# RENESAS TECHNICAL UPDATE

Product Category	MPU & MCU	Document No.	TN-RX*-A069A/E	Rev.	1.00
Title	Errata to RX630, RX63N, RX631, and RX63T Groups User's Manuals Regarding CAN Module		Information Category	Technical Notification	
Applicable Product	RX630 Group RX63N Group, RX631 Group RX63T Group	Lot No.	Reference Document	RX630 Group User's Manual: Hardware Rev.1.50 (R01UH0040EJ0150) RX63N Group, RX631 Group User's Manual: Hardware Rev.1.60 (R01UH0041EJ0160) RX63T Group User's Manual: Hardware Rev.2.00 (R01UH0238EJ0200)	
		All

This document describes corrections to the chapter "CAN module" in the User's Manuals: Hardware of the above groups.

**Figure 34.9 Transition between CAN Operating Modes**

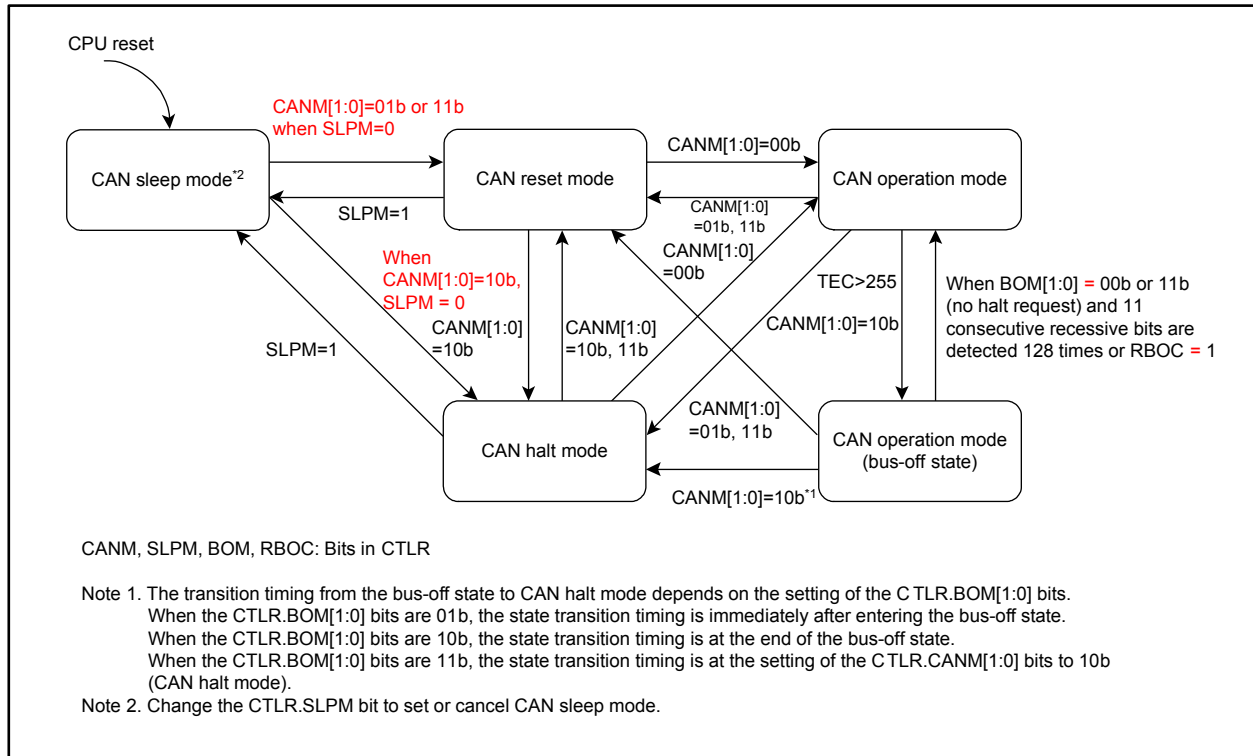
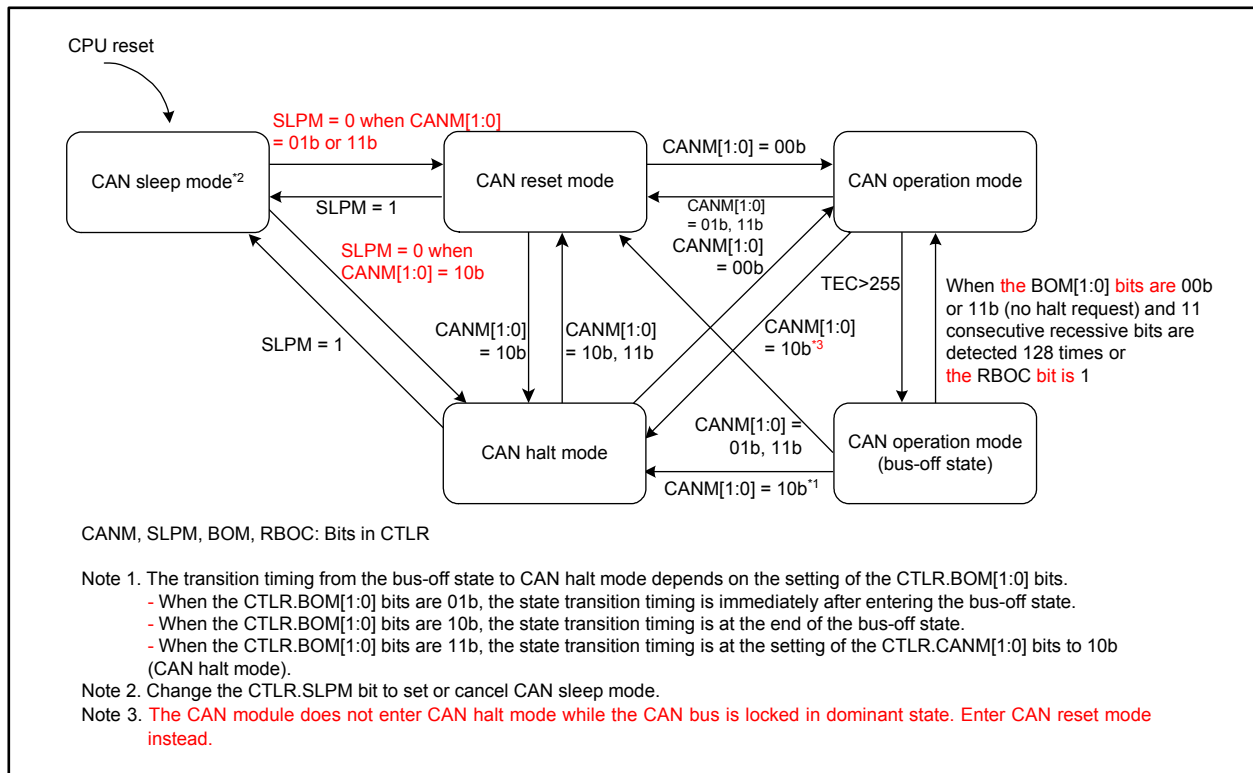
•Page 1254 of 1654  
 Figure 34.9 is corrected as follows:
